Title - Sujet Réfection du quai de Percé	
Solicitation No. - N° de l'invitation F3731-190020/A	Amendment No. - N° modif. 005
Client Reference No. - N° de référence du client 722797002	Date 2019-10-09
GETS Reference No. - N° de référence de SEAG PW-\$QCM-032-17752	
File No. - N° de dossier QCM-9-42095 (032)	CCC No./N° CCC - FMS No./N° VME
Solicitation Closes - L'invitation prend fin at - à 02:00 PM on - le 2019-10-17	Time Zone Fuseau horaire Heure Avancée de l'Est HAE
F.O.B. - F.A.B. Plant-Usine: <input type="checkbox"/> Destination: <input checked="" type="checkbox"/> Other-Autre: <input type="checkbox"/>	
Address Enquiries to: - Adresser toutes questions à: Girard, Isabelle	Buyer Id - Id de l'acheteur qcm032
Telephone No. - N° de téléphone (418) 649-2847 ()	FAX No. - N° de FAX (418) 648-2209
Destination - of Goods, Services, and Construction: Destination - des biens, services et construction:

AMENDMENT 005

TITLE: RECONSTRUCTION OF PERCÉ'S WHARF, PERCÉ, GASPÉSIE, QUEBEC

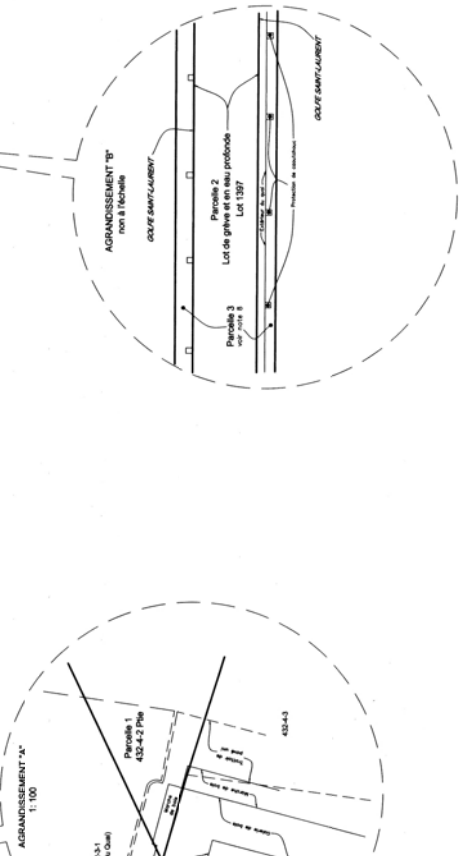
- a) In the specs, Section 01 11 01 -1.7 USE OF PREMISES BY CONTRACTOR, you indicate that land would be available on Biard Street. Can you give us the address to view the site?
- b) Would it be possible to clearly state the property boundaries thus establishing the limits of use of the premises?
- c) Is the path owned by the municipality?

- a) Contact the City for this purpose.
- b) The property drawing is provided hereinafter.
- c) Yes.
